**ADDENDUM NO. 1**

**PROJECT NAME:** City Campus Utility Plant North Cooling Tower Replacement General Installation Contract Package

**UNL PROJECT NUMBER:** C028P241  
**BID INVITATION NUMBER:** 2247-13-7200

**CONSULTANT:** Lutz, Daily & Brain, LLC  
6400 Glenwood, Suite 200  
Overland Park, KS 66202

ISSUED FOR BID, 40213-CCUP-NCT-E6, SHEET NUMBER 12

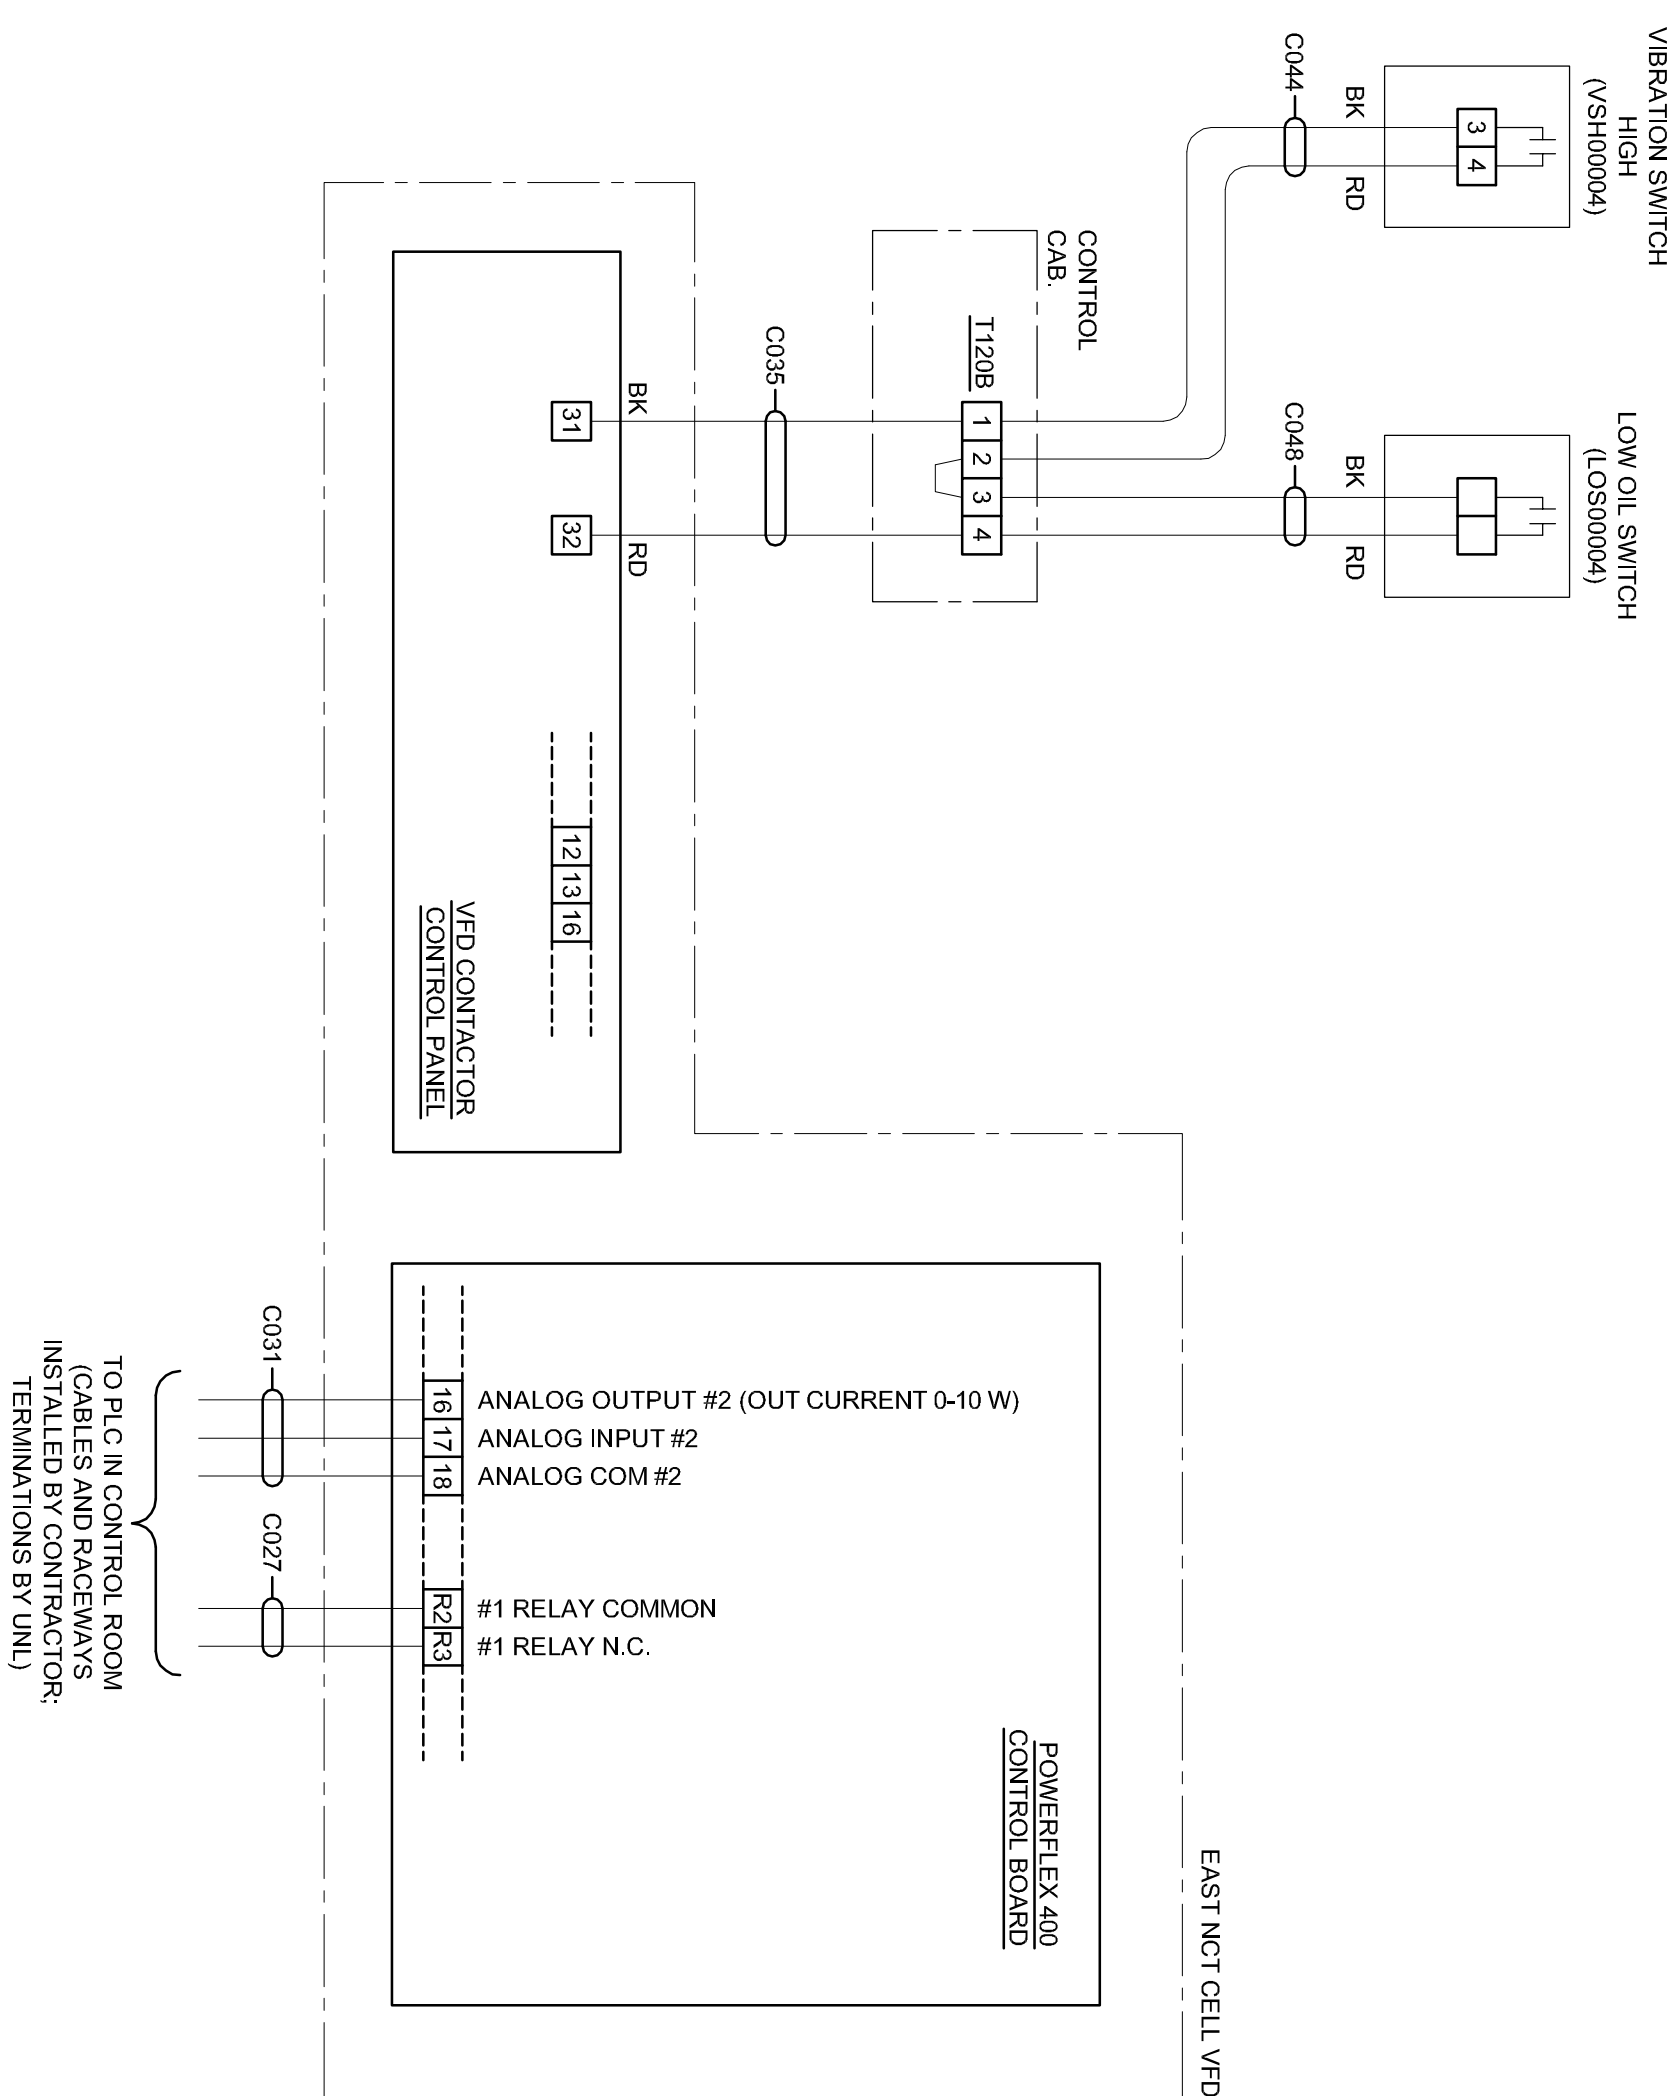
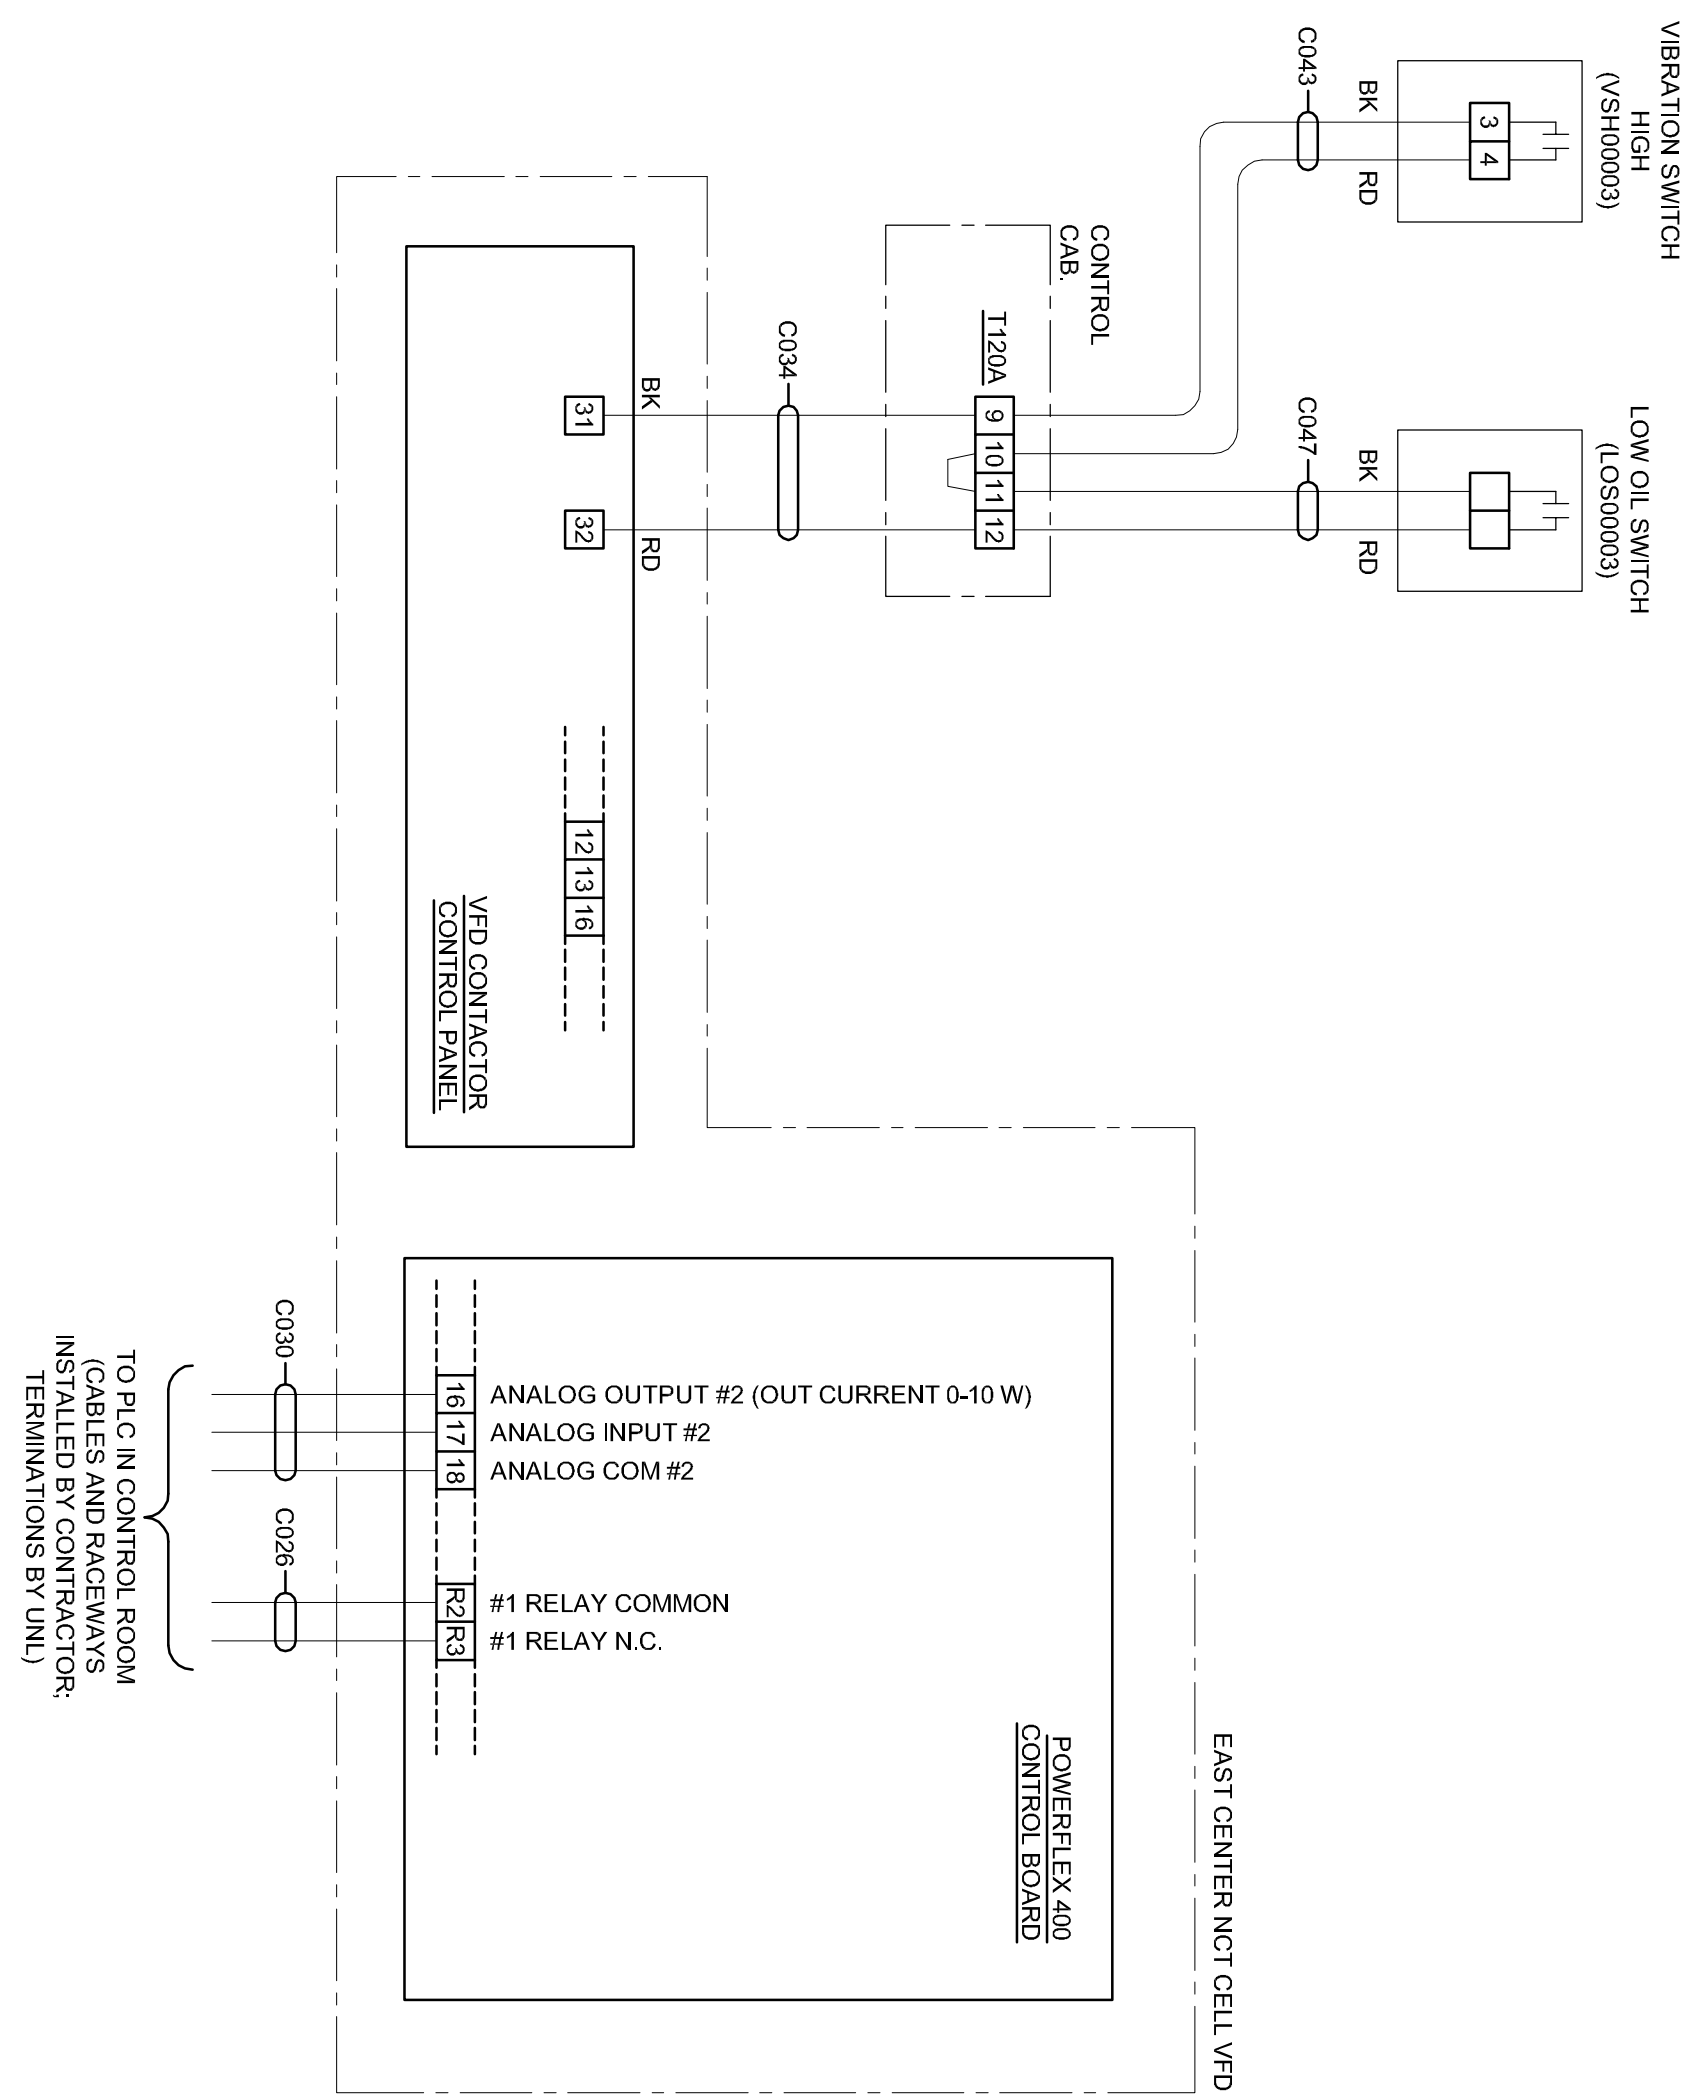
- 13.1 Drawings 40213-CCUP-NCT-E2, E3 & E4: 480V Hoffman enclosure removed from plan views.
- 13.2 Drawing 40213-CCUP-NCT-E6:
  - Circuit P005 increases in length from 80' to 155'.

- Circuit P006 increases in length from 160' to 235'.
  - Circuit P007 increases in length from 80' to 155'.
  - Circuit P008 increases in length from 105' to 180'.

- Circuit P009 increases in length from 130' to 205'.
  - Circuit P010 increases in length from 160' to 235'.
  - Circuit P011 decreases in length from 150' to 75'.

- Circuits P005-P010 "From" designation shall read "New 480V panel in basement" instead of "New j-box".
  - Circuit P011 "To" designation shall read "New 480V Panel in basement" instead of "New junction box".

- Raceway R045 "From" designation shall read "New 480V panel in basement" instead of "Duct Bank in CCUP basement".
  - Raceway R068 added to Raceway list and goes from new 480V panel to duct bank.

Raceways R005-R010 "From" designation shall read "new j-box at NCT" instead of "480V box".

Raceway R054 from new junction box to Hoffman box is deleted.
